Certificate of Appropriateness

Property	1104 W. HISTORIC MITCHELL ST.	Mitchell Street HD
Description of work	Build new wood storefront in a historic style with recessed double door center entrance. Bulkhead design shall be of three piece construction for panel detail: flat back panel, pierced flat front panel, and molded trim connecting the back and pierced panels. Storefront shall be painted or use an extremely dark wood stain (e.g., walnut, mahogany). See attached plans. Install symmetrically spaced downlighting fixtures over storefront. Clean and tuckpoint brick as needed. Repair roof structurally and install membrane roof system as needed in area that is approximately 30'x40'.	
Date issued	4/5/2018	PTS ID 114478 COA: storefront and roof

A1 PROPOSED EXTERIOR FRONT REMODELING ELEVATION
 1/4" = 1'-0"

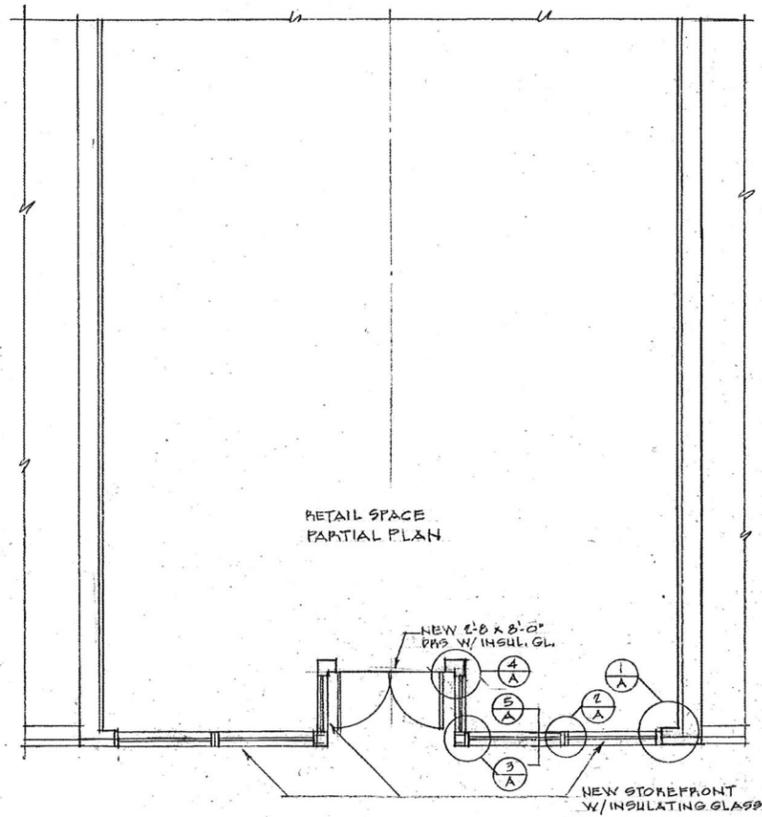
Disregard doors on this page, see attached plans.
